DATE: January 27, 2006

Addenda No. 2

SUBJECT: OR 38: Scottsburg to Scotts Creek Resurfacing
Umpqua Highway
Douglas County
Paving, Guardrail Project
(Bids to be opened and read February 9, 2006)

OREGON DEPARTMENT OF TRANSPORTATION ROADWAY ENGINEERING SECTION	
OR38:SCOTTSBURG TO SCOTTS CREEK RESURFACING UMPOUA HIGHWAY DOUGLAS COUNTY	
Design Team Leader - James Burford Designed By - Josh Lonie Drafted By - Tony S. Johnson	
DETAILS	SHEET NO. 2B-3

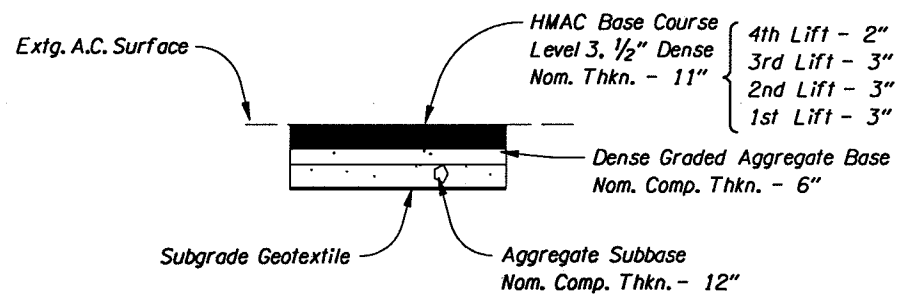
1. Plan sheet 2B-3 is replaced with revised plan sheet 2B-3.

Revised 1-26-06, Removed Localized Pavement Repair Detail
